National Standard Plumbing Code

2024 PROPOSED CHANGES

to the 2021 NATIONAL STANDARD PLUMBING CODE

NSPC Public Hearing

Code Section: Figure 9.3.4 Standpipe Receptors

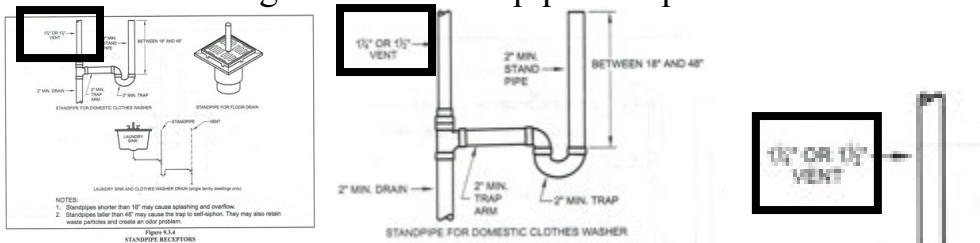
Basis/Reason for Change: The trap arm and drain size are both shown as "MIN." (minimum) in Figure 9.3.4. The Figure will be uniform once the change is made. Figures should display the minimum Code requirements. Additionally, clothes washer standpipes and washer boxes are commonly vented with 2" pipe, which is the same size as the minimum drain.

FIGURE N 104.1
WATER TEMPERATURE RANGES AND LEGIONELLA GROWTH POTENTIAL*

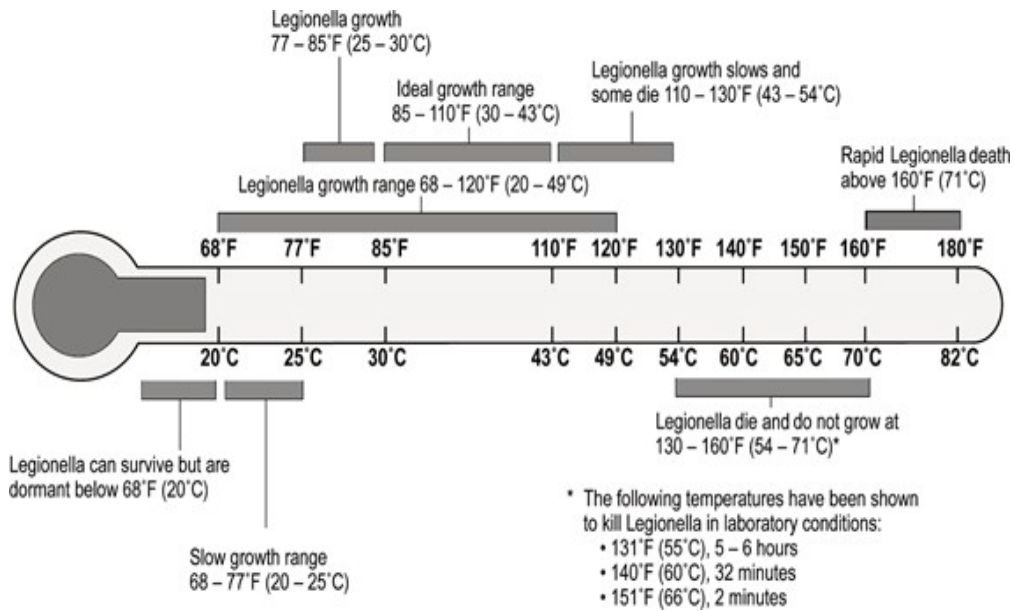
N 104.1 Legionella Growth Potential. The Authority Having Jurisdiction shall have the authority to require documentation to address Legionella growth potential, where water temperatures in a water distribution system are within ranges shown in Figure N 104.1 that pose a Legionella growth potential.

Additionally Included, in the recommendation is Figure N 104.1 that is specifically scaled for Legionella growth potential. Figure N 104.1 and Table N 104.2 simplify the temperature ranges for Legionella growth potential and scald potential and adds clarity for the end user on the use of the figures and assists when acquiring the important information needed. The appendix also includes a distinction between chemical and non-chemical disinfection and treatment criteria, remediation guidelines for domestic water, and an emergency disinfection procedure.
